Name of Project: Cell 8 Construction - J.E.D. Solid Waste Management Facility

Regarding: Omni Waste of Osceola County, LLC
J.E.D. Solid Waste Management Facility, St. Cloud, Florida
Cell 8 Construction; Response to "Review of Construction Certification Report"

**CONSTRUCTION QUALITY ASSURANCE
CERTIFICATION REPORT
CONSTRUCTION OF CELL 8**

**Liner Layout
Plan**

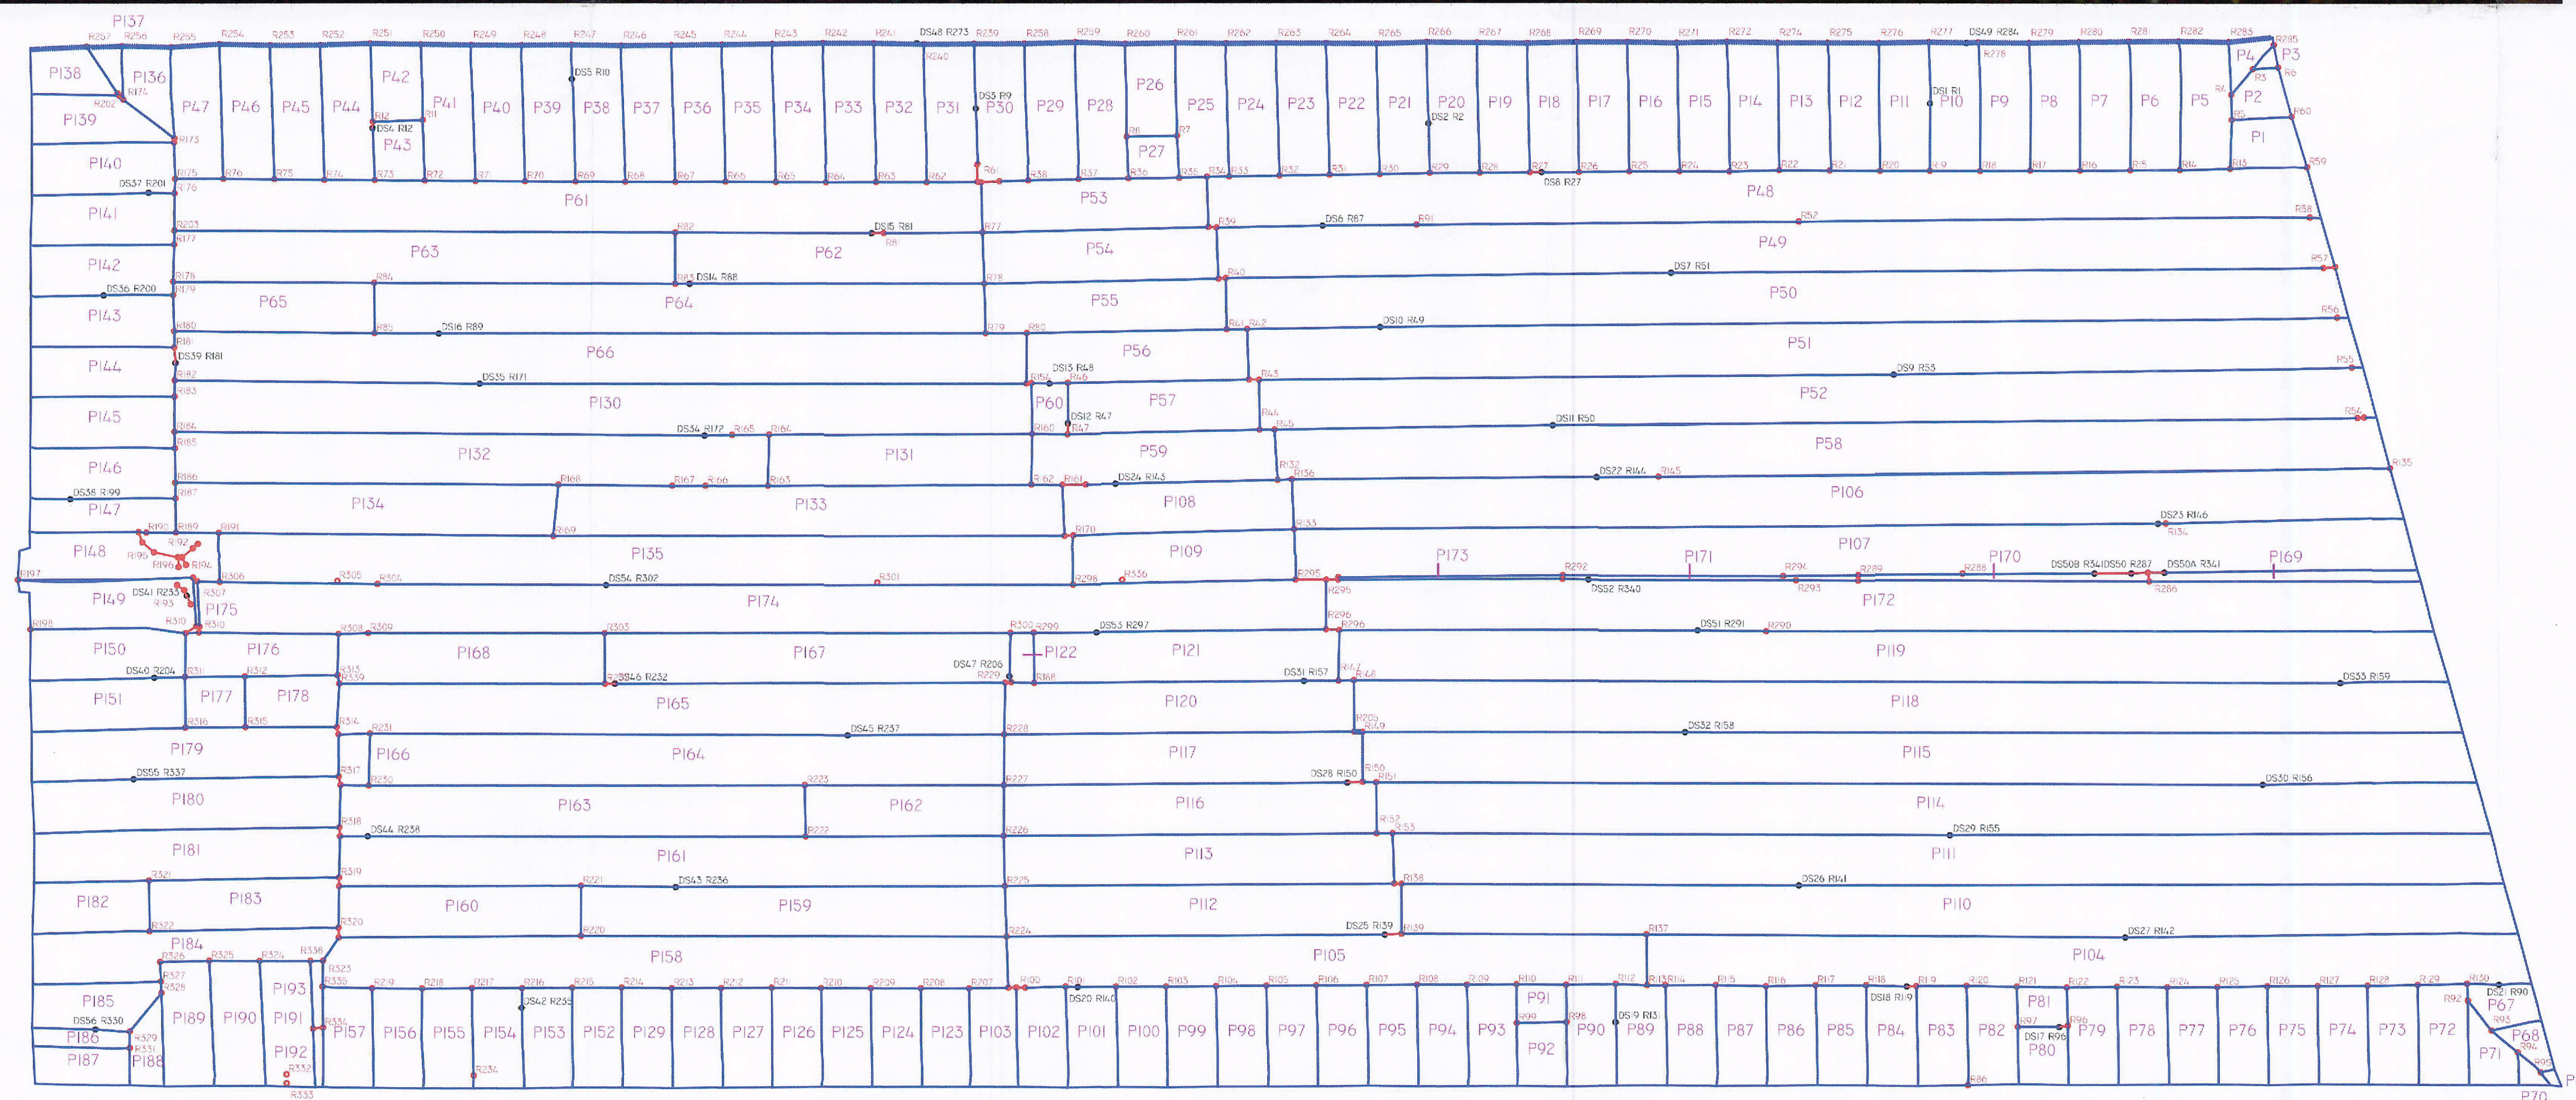
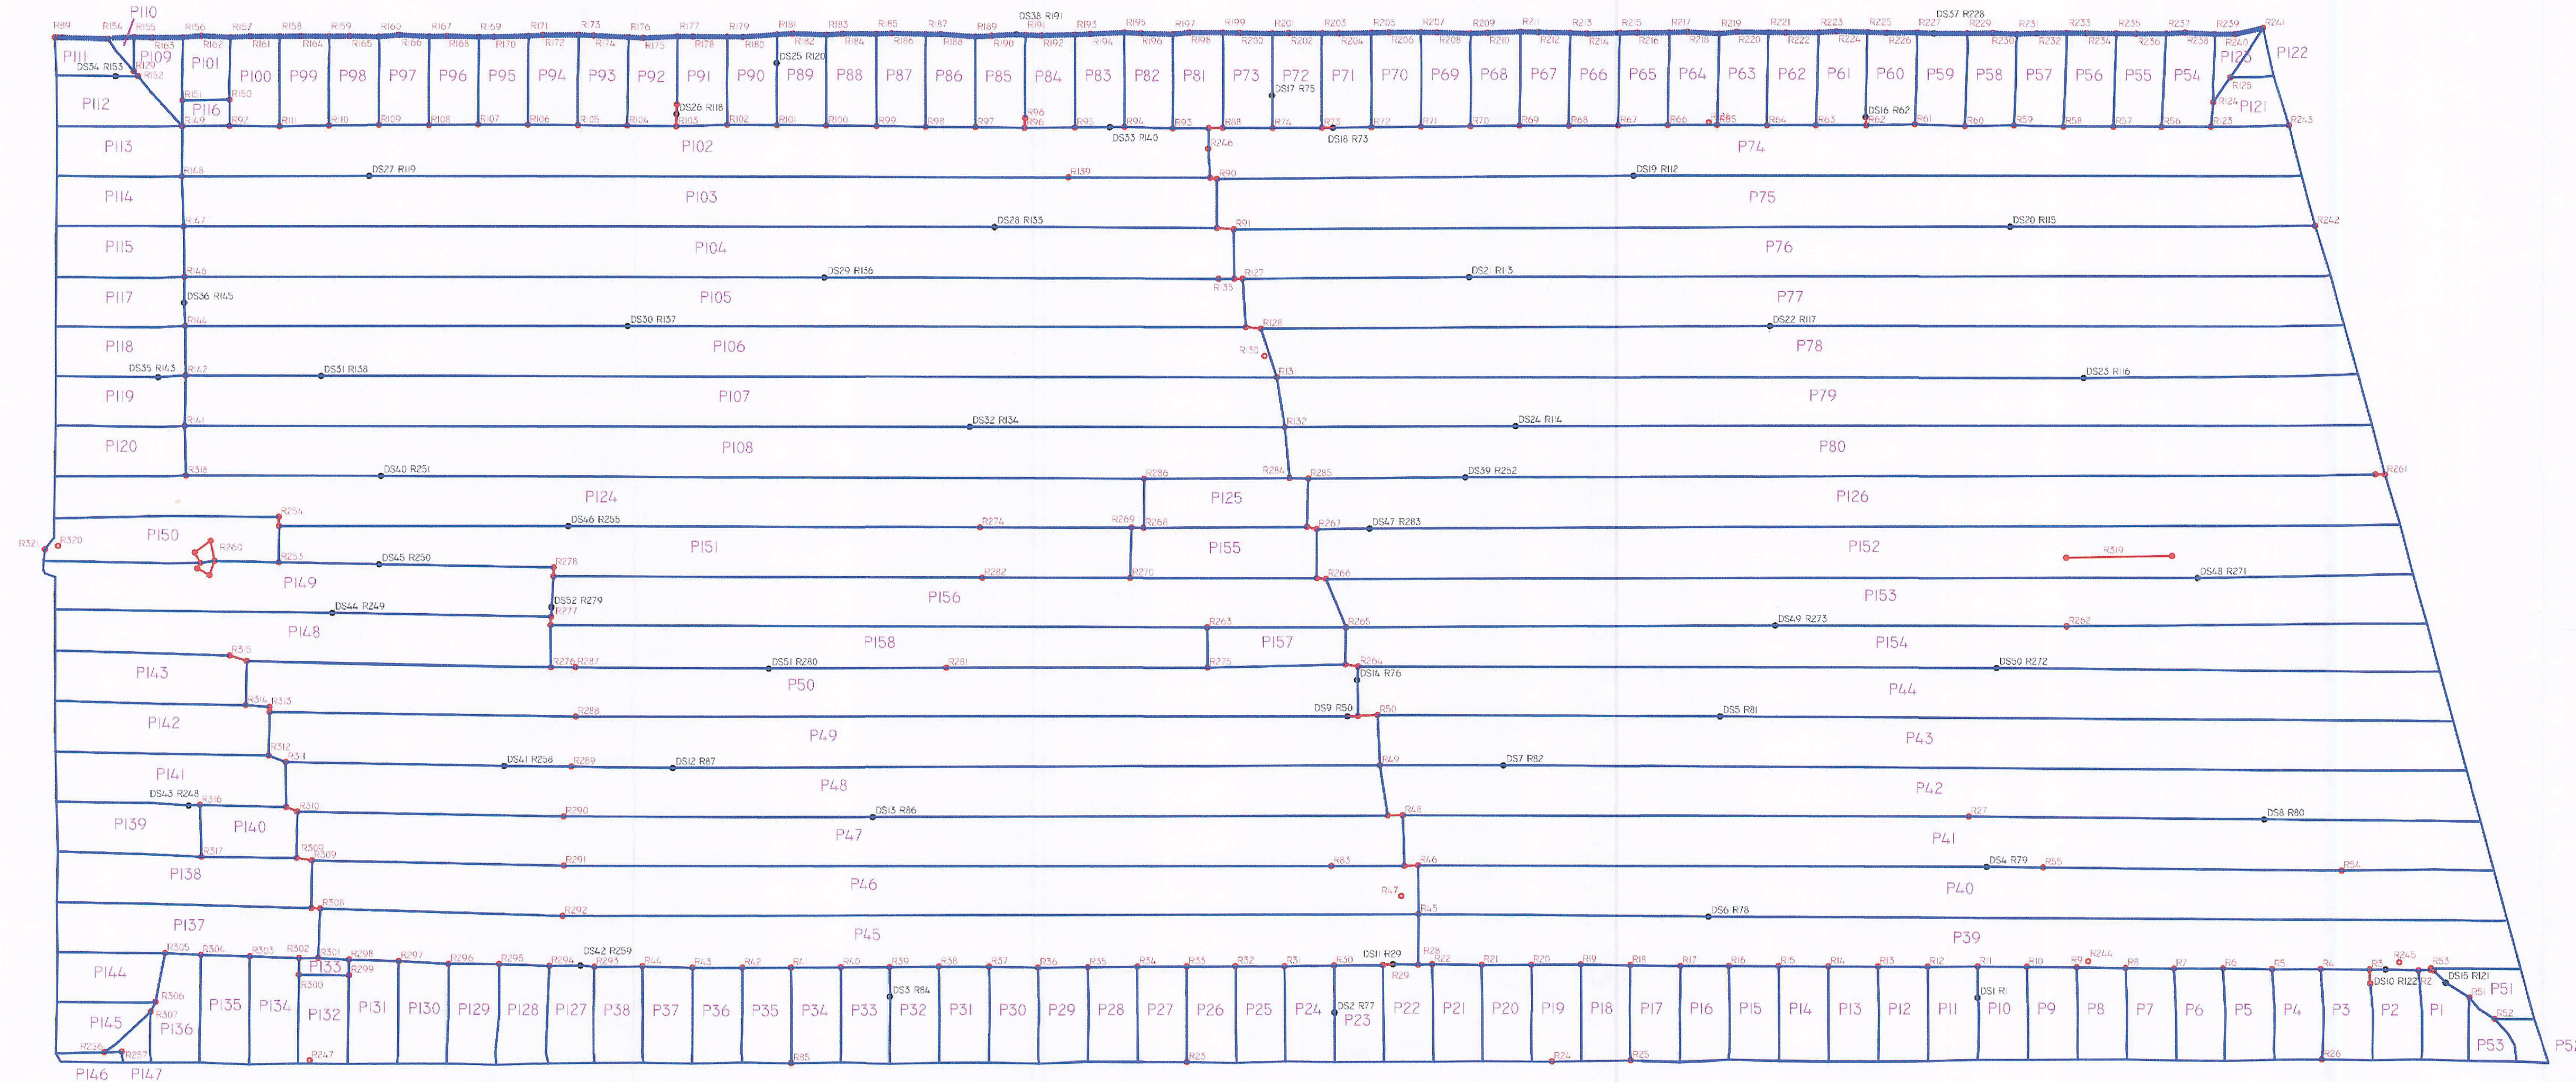
- 7. Please provide panel layout drawings for the installation of the primary and secondary geomembrane layers.**

The panel layout drawings have been certified by a registered professional and are included in this response package to be inserted in Appendix A of the Report.

SCALE 1" = 50'	DRAWING NO. 185
PROJECT NO. 128	SHEET 1

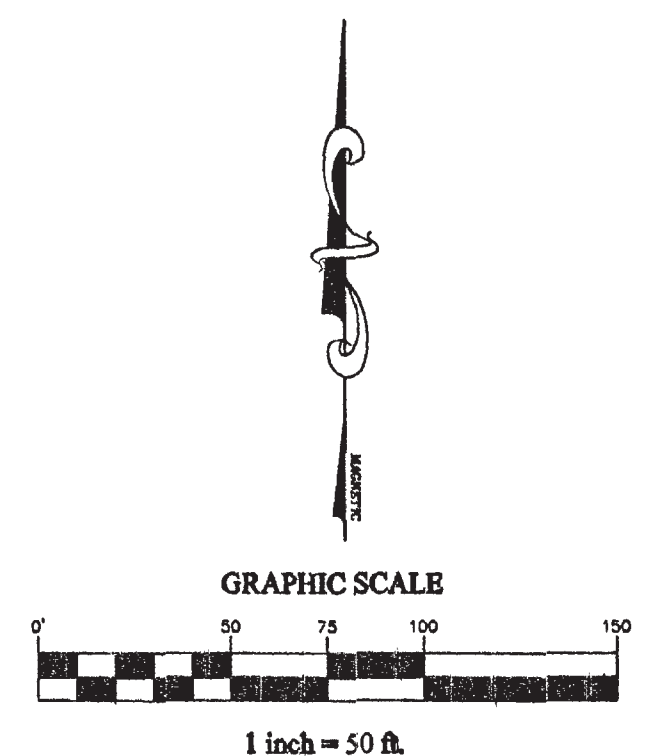
- 1. The As-Built Drawings submitted as part of the Report have callouts which refer to notes. For example, Drawing No. 185, sheet 1 states SEE NOTE 2. Are the callouts relevant to the as-built information? If yes, submit a copy of the notes referenced in the As-Built Drawings. Or, were they part of the originally submitted drawings but do not have information important for the as-built submittal.**

The As-Built Drawings have been revised by the land surveyor to remove notes, callouts, and citations that were residuals from the original design plans. Signed and sealed hardcopies of the revised As-Built Drawings are included in this response package to be inserted in the original Report copies provided to the FDEP.
